MECKLENBURG COUNTY
DEPARTMENT OF ENVIRONMENTAL HEALTH

APPLICATION FOR SOIL INVESTIGATION

SITE INVESTIGATION REPORT
INDIVIDUAL SEPTIC TANK SYSTEM
WITH SUBSURFACE,
SOIL ABSORPTION,
EFFLUENT DISCHARGE

SIR No. 12382
T.C. No. 211-191-07
L.P. No. _____

DIAGRAM OF PROPERTY

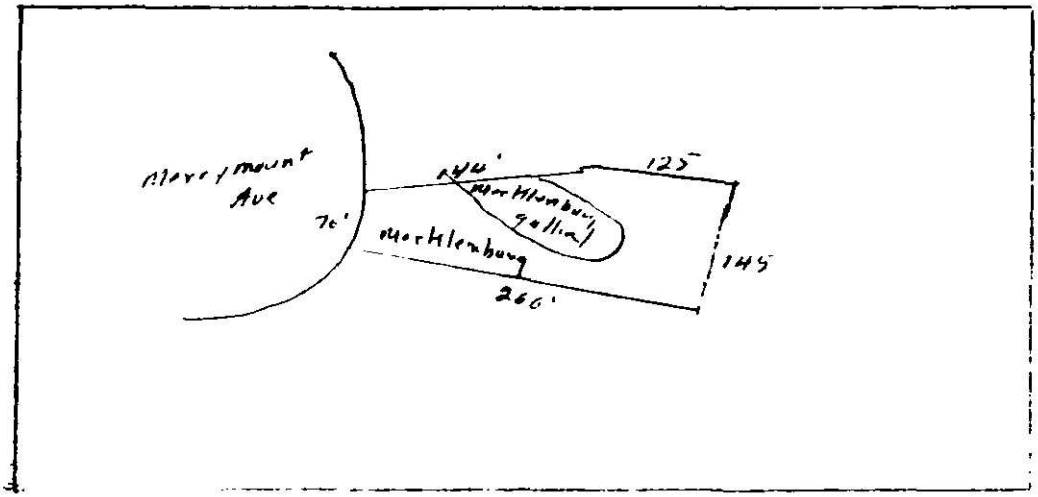
Remarks ~~Recommendations~~ Based on the investigation, this lot was found to be unsuitable for the installation of a septic tank system.

See diagram on back
